# CARNBUCK WIND FARM

## Further Environmental Information 2025

### Volume 1 - Non-Technical Summary

This Further Environmental Information (FEI) 2025 has been prepared in support of the planning application for the proposed Carnbuck Wind Farm, planning reference SPD/2023/0951/F. The proposed wind farm is located approximately 4.4km north east of Cloughmills and approximately 12 km south west of Cushendall in the townlands of Carnbuck, Magheraboy and Moneyneagh, east of Corkey Village. The planning application was validated in March 2023.

PROJECT TITLE	CARNBUCK WIND FARM	
DRAWING TITLE	HABITAT MANAGEMENT GRUIG & CARNBUCK	
RES DRAWING NUMBER	FIGURE 3.1	REV 0

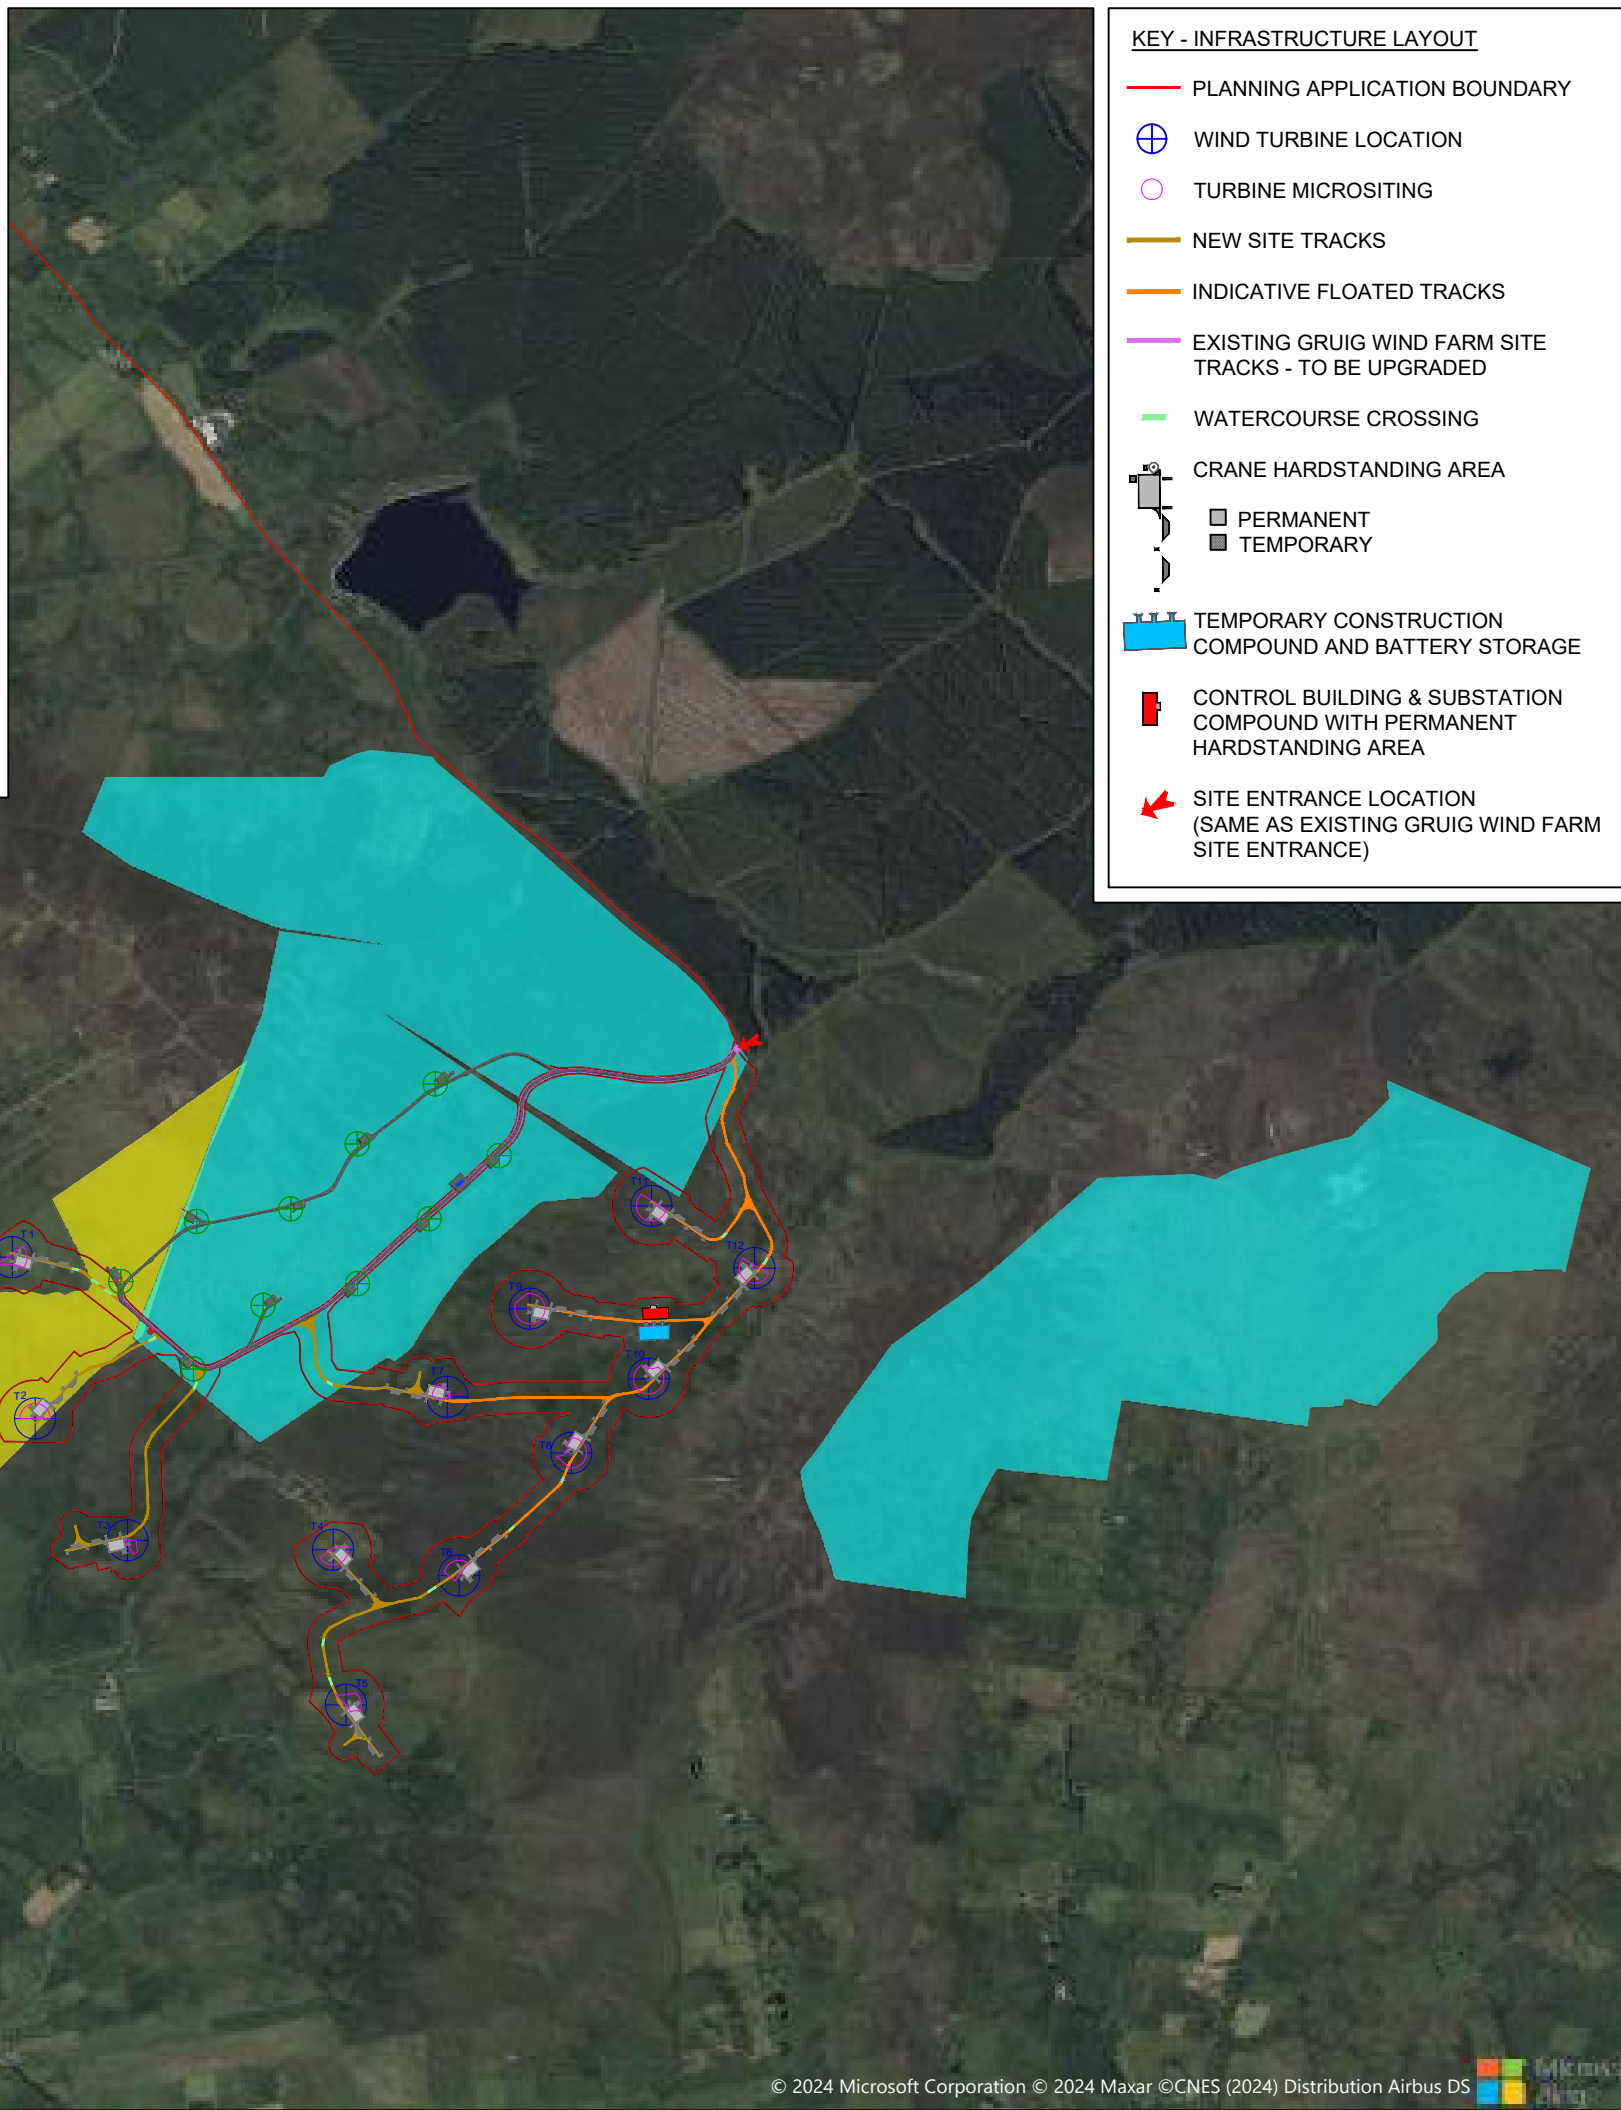
- 3.3 NED requested that active peat maps are produced of the areas around the proposed track east of Turbine 6 and the tracks to the east and west of Turbine 7. In addition, NED requested a map to show the Gruig HMP and Carnbuck HMP areas. Maps are now presented within the FEI to illustrate the location of the active peat areas and the locations of the Gruig HMP and Carnbuck HMP areas, clarification has been provided with regards to the location of active peat.

- 3.13 A map of the whole proposed Carnbuck oHMP area and the Gruig HMP area is presented in Figure 3.1.

**FIGURE 10.1 (Rev3)**

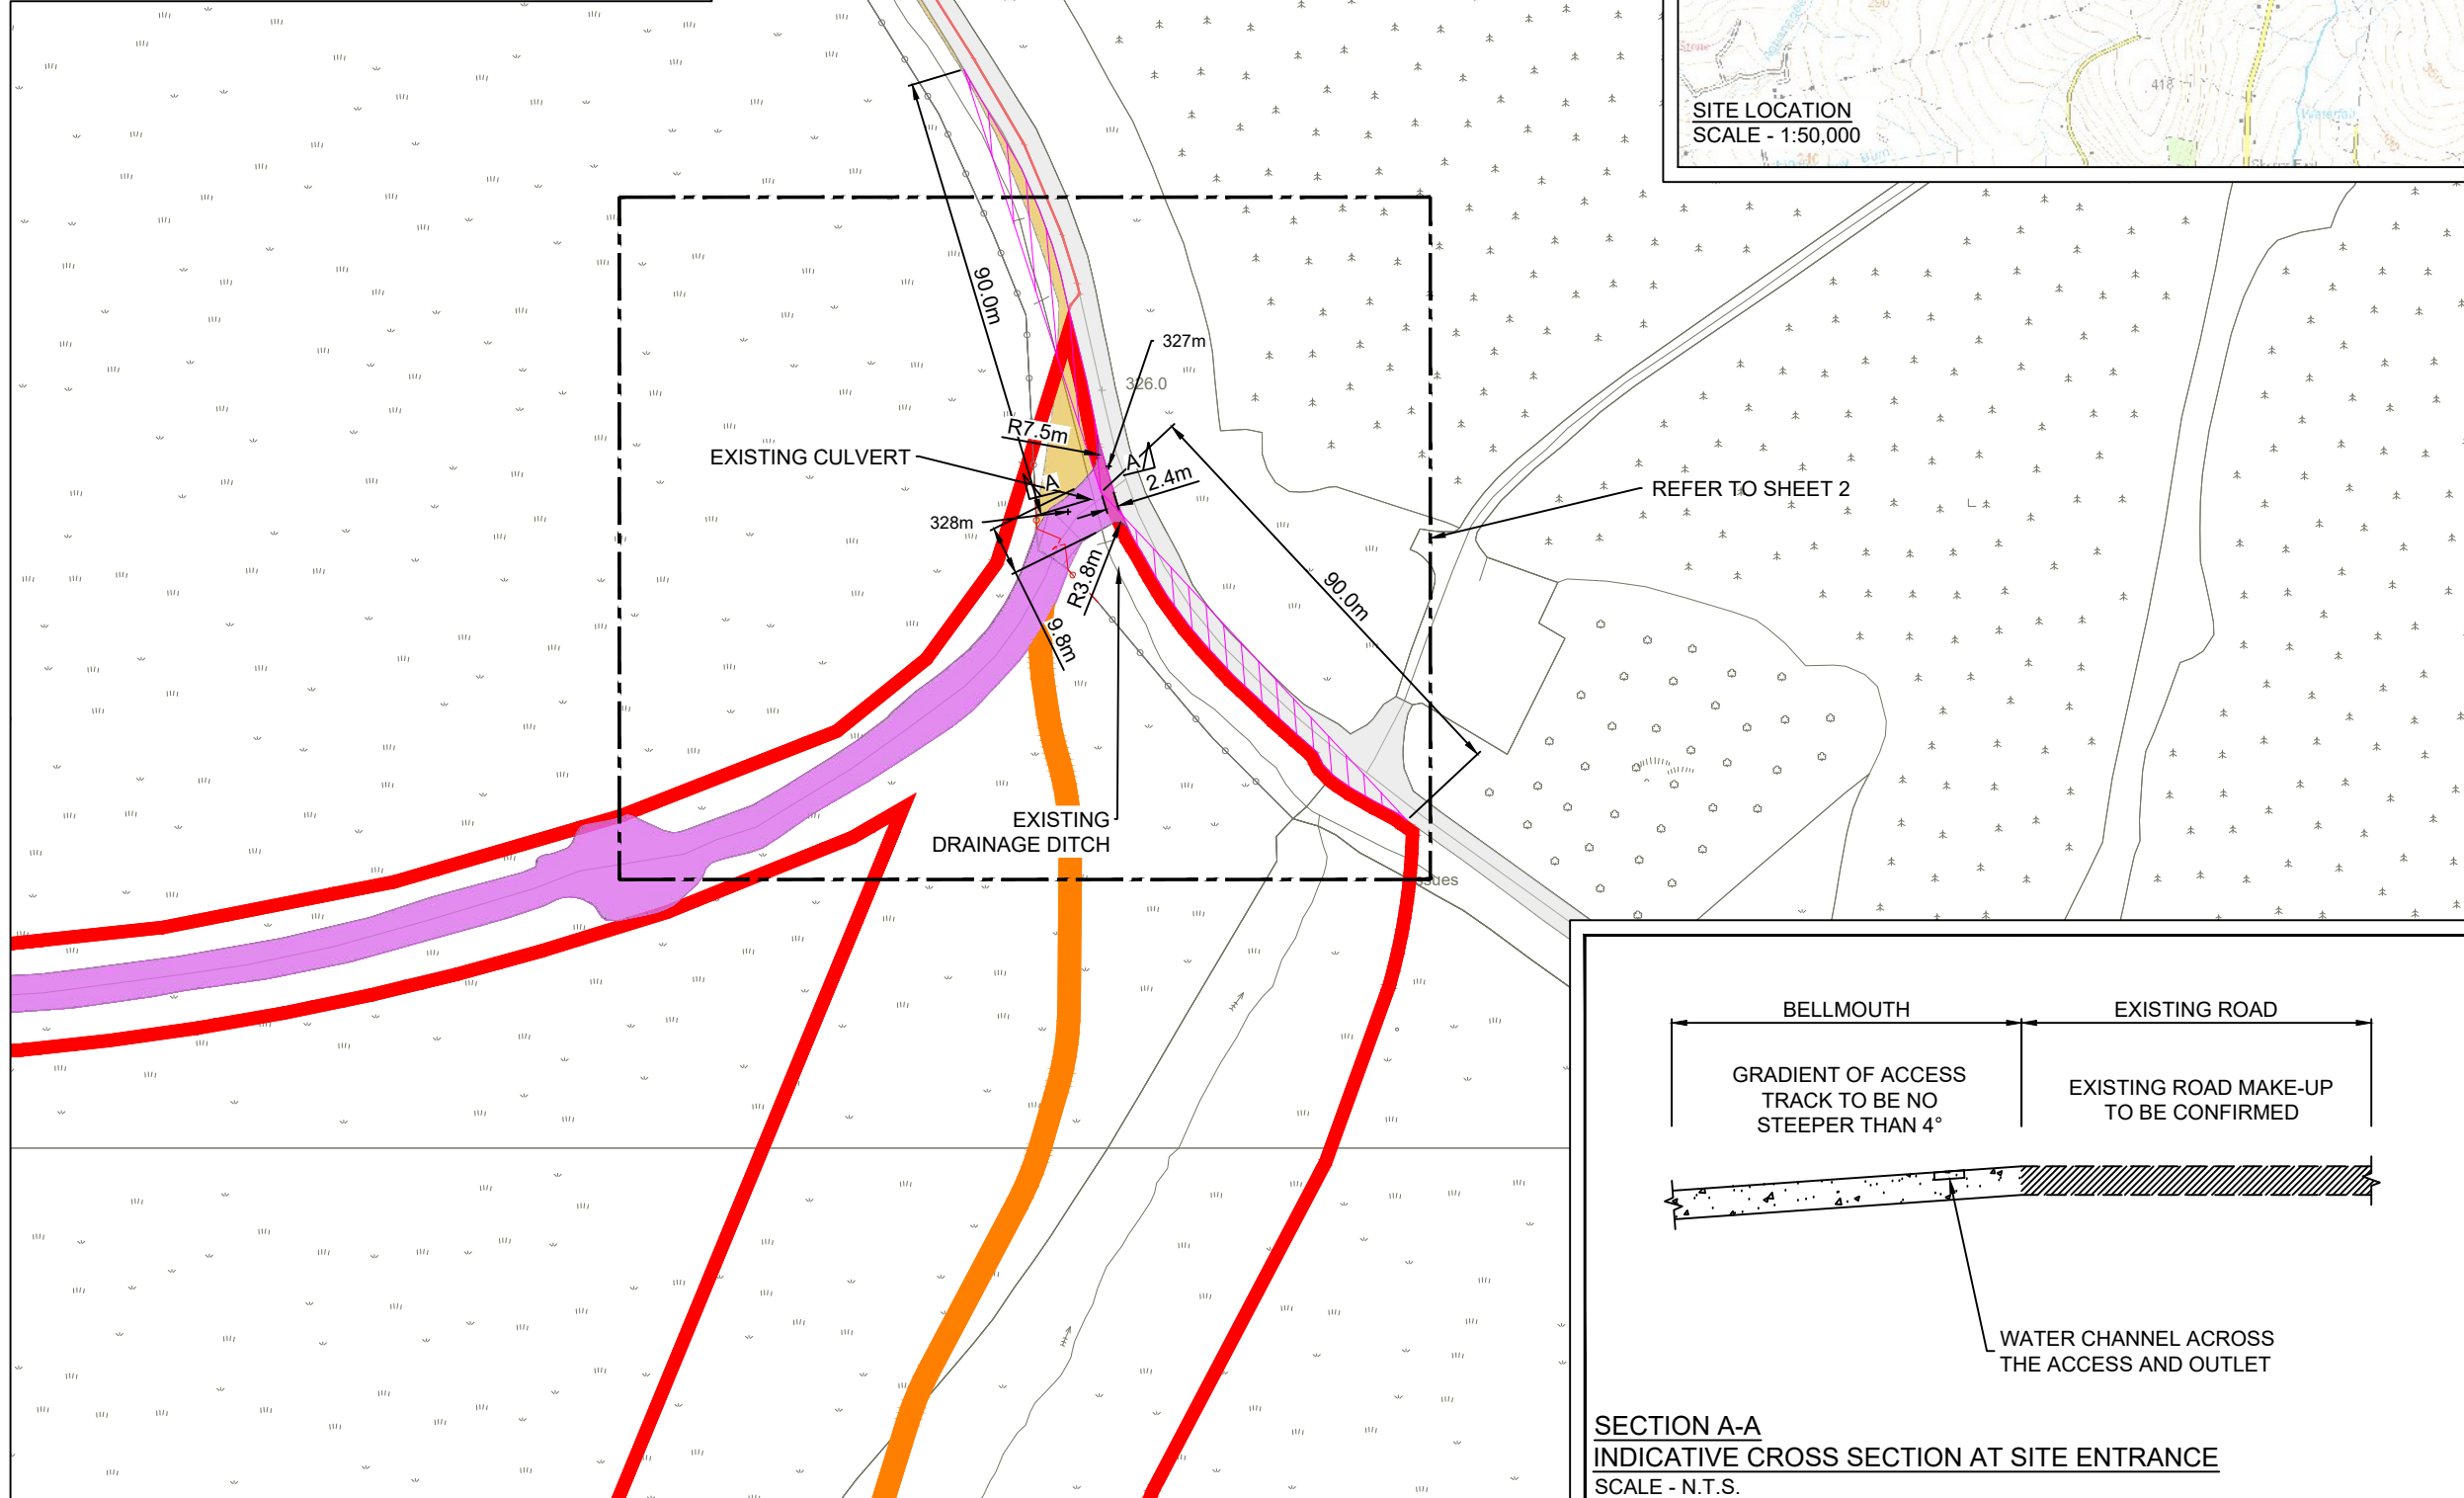
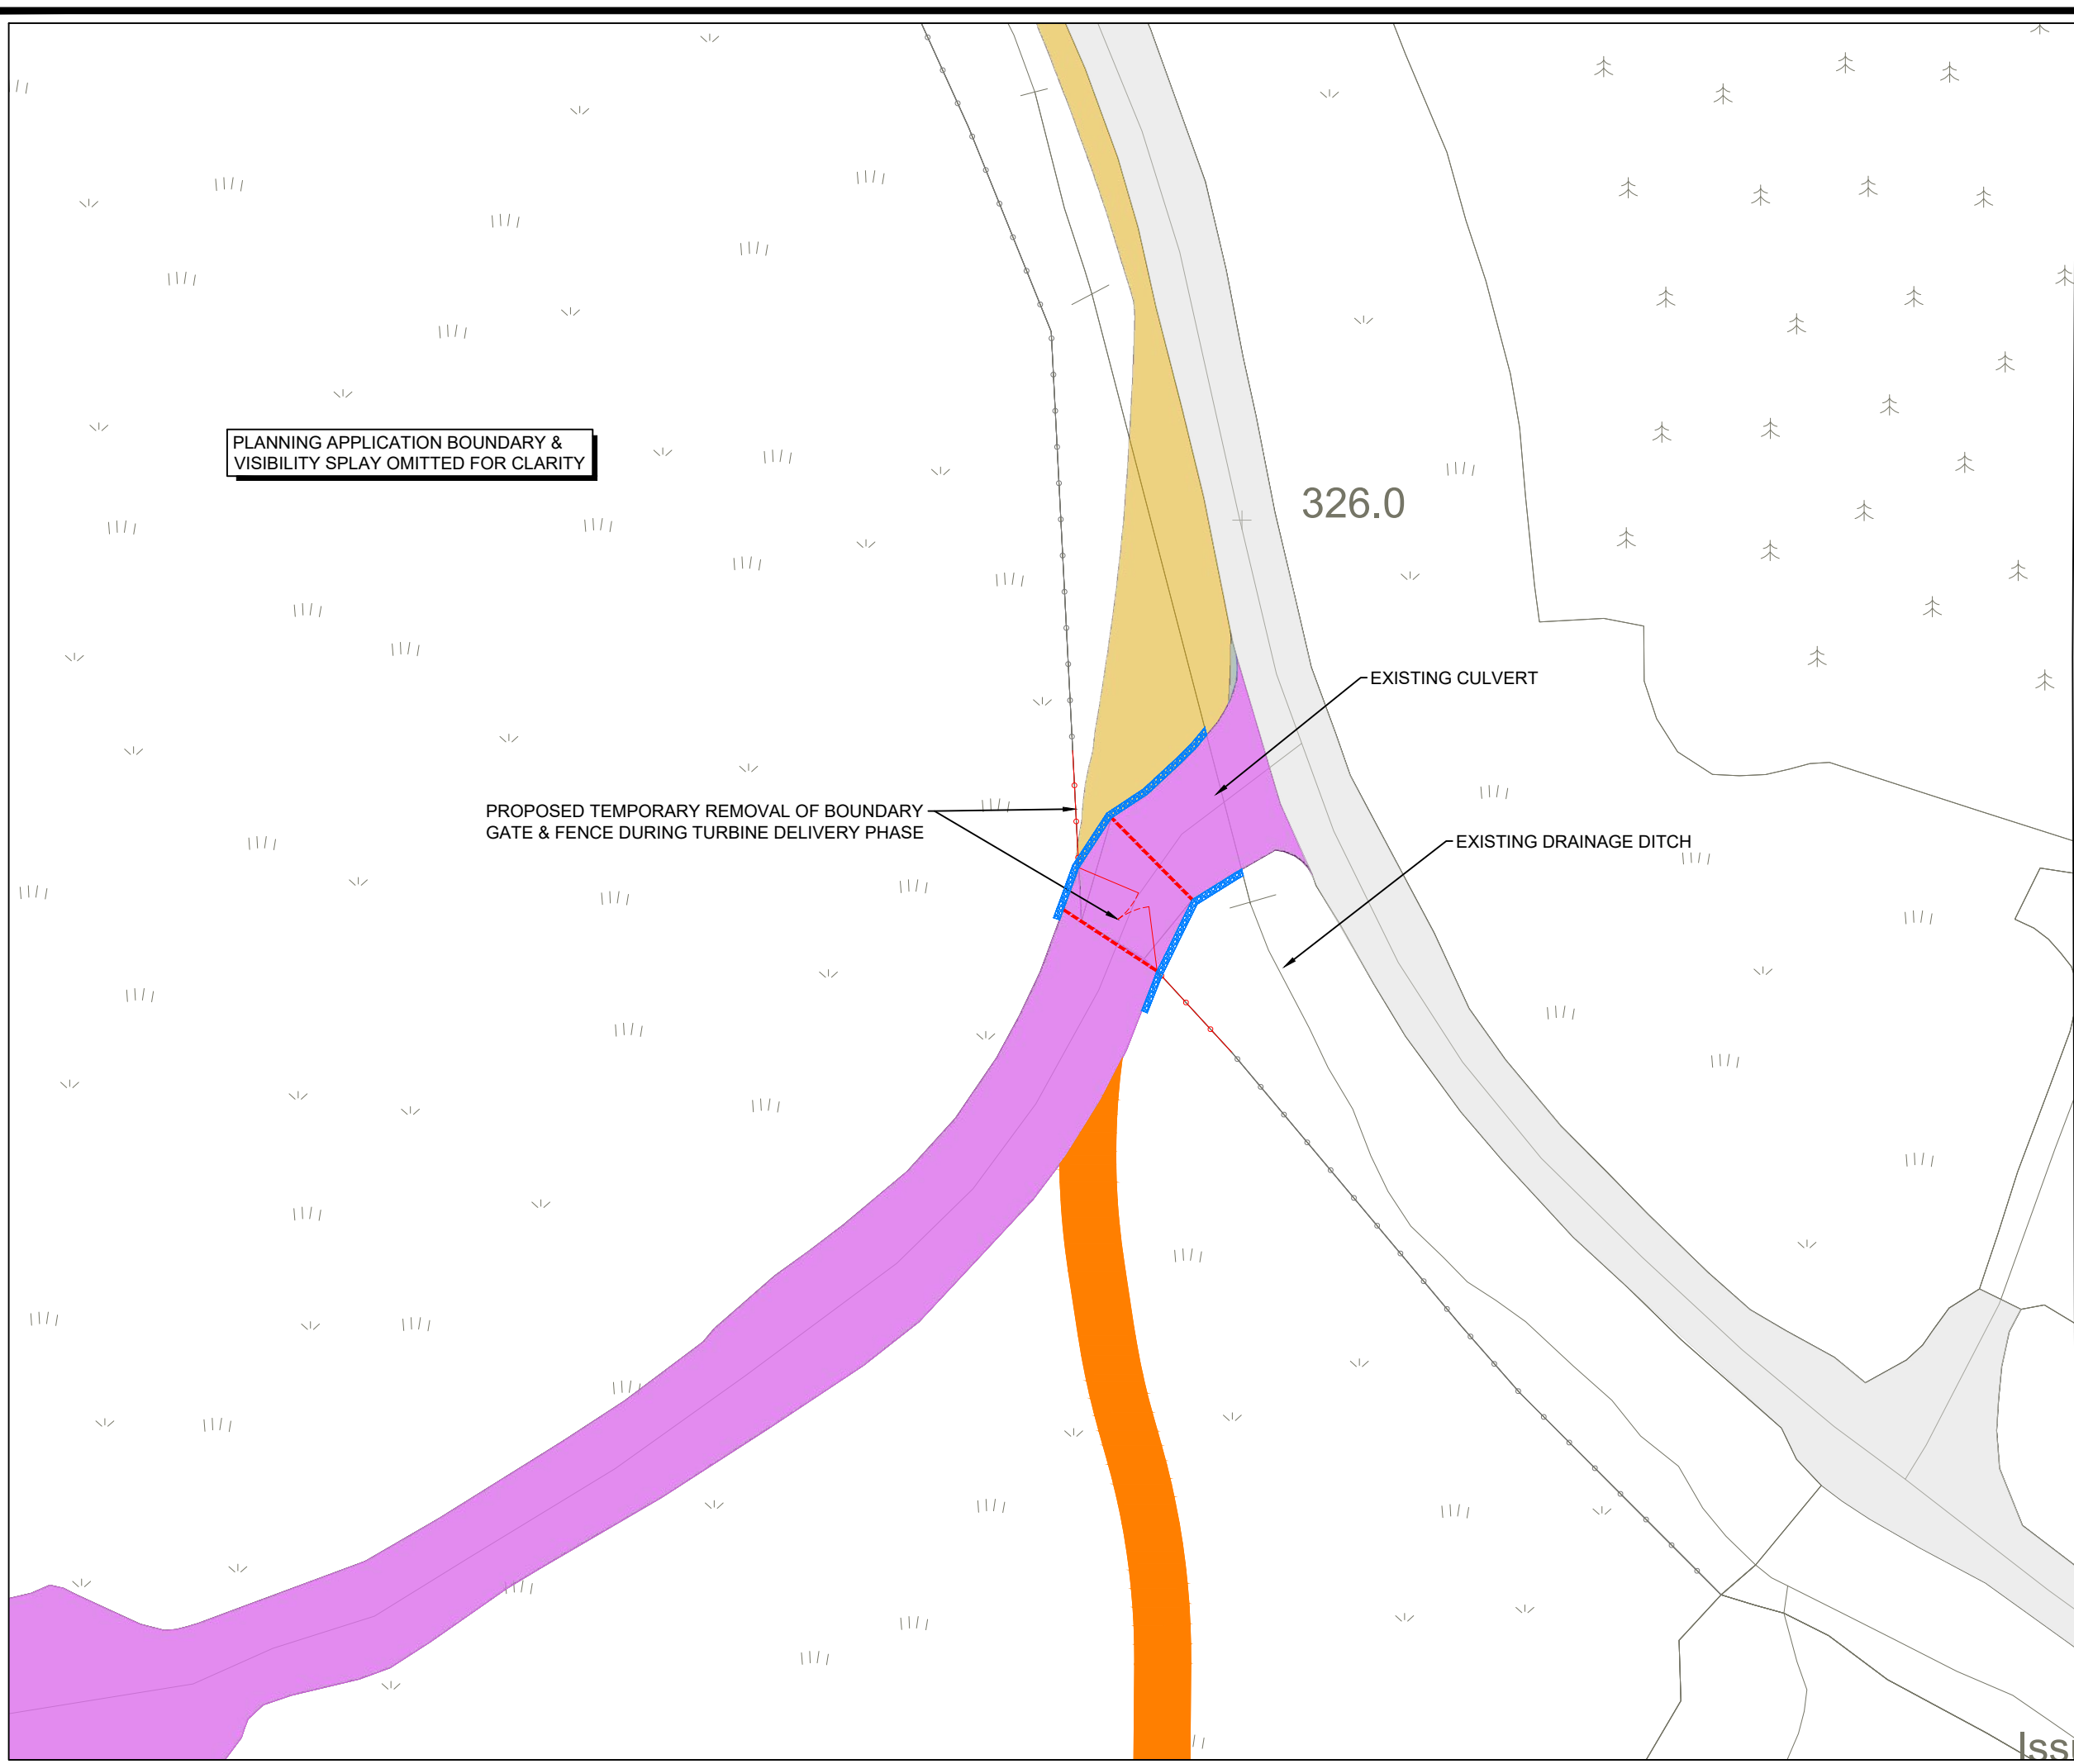
- 5.1 The Department for Infrastructure Roads (DFI Roads) consultation letter response letter dated the 7<sup>th</sup> of April 2023 requested further information in relation to the Site Entrance Drg. 34 which should show the following detailed in accordance with DCAN15.

- 5.2 The previously submitted Site Entrance Drawing (Figure 10, Stamped Drawing 34) has been updated to include the required information above.
- 5.3 The updated site Entrance Drawing is included as **Figure 10.1 (Rev 3)**
